PLAN REVIEW SHEET

2016-138

Southminster, Inc.

Bus stop pad detail

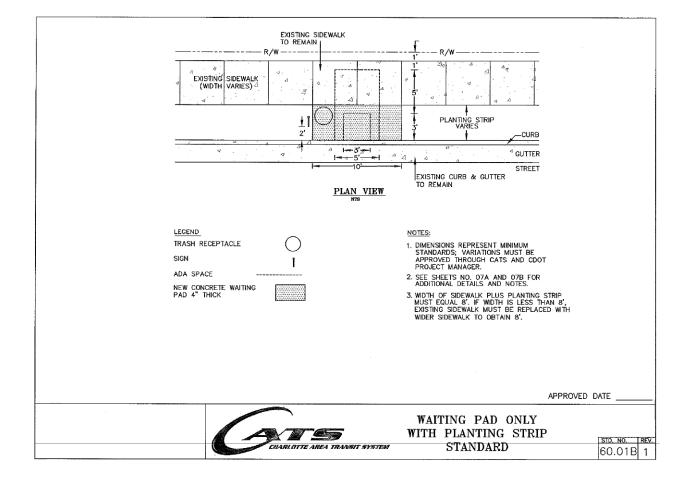
This site is located on an existing bus route. The Petitioner is requested to provide and construct a new waiting pad for a relocated bus stop on Park Road. The recommended new location is within the planting strip along Park Road, at least fifty feet north of the development entrance so that a stopped bus will not block the entrance.

Below is an image of the standard detail (60.01B) for the requested bus stop pad. Permanent easement is requested, where dimensions exceed existing or proposed right-of-way limits.
